**Title:** TX-DS989

**Application:** Service Tip

Main Micro-processor Section

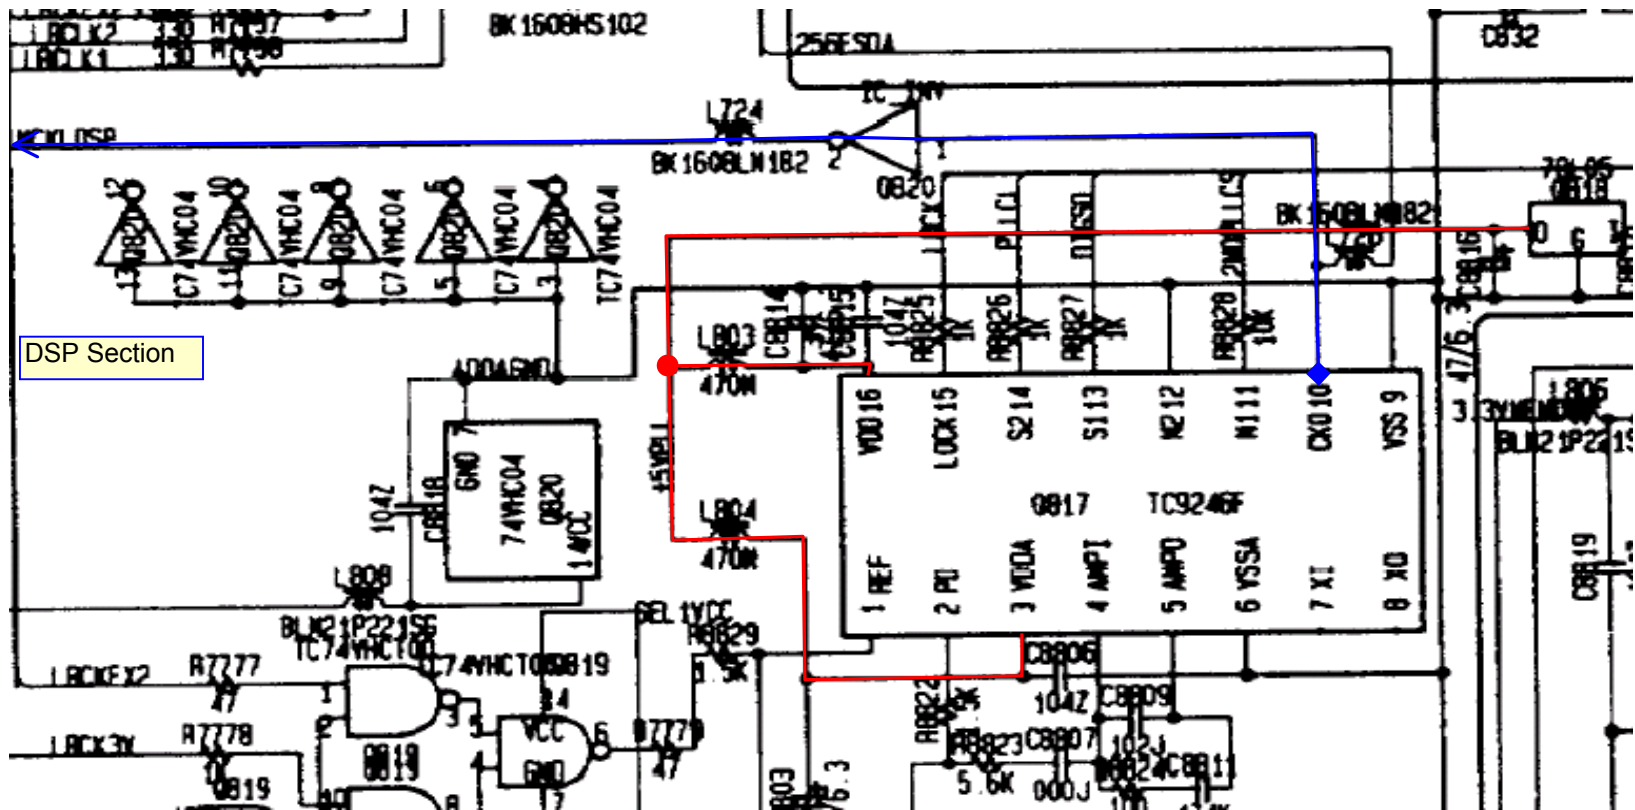
Do to aging an environment (warm) in which a unit may be working, some units may experience power supply failure as a result of cold solder point around Q9203 legs on Main Micro Processor PCB (NAAR-6837-1), Q9302, Q9322, Q9304 and 9303 on Power supply regulator PCB.

A loose connection at Q9203 is known to cause Poor Video, Distorted Audio and malfunction of Q817, Q820 having direct relation to the DSP master clock error.

The failure of this section of the DSP is very critical and that the reproduction experience as stated by a consumer can differ from one customer to the next. Therefore it is very important that one makes all the appropriate touchups on all regulator components and inter connecting wires in the case of NCPS-6839 and NCPS-6838 power supply PCB's.
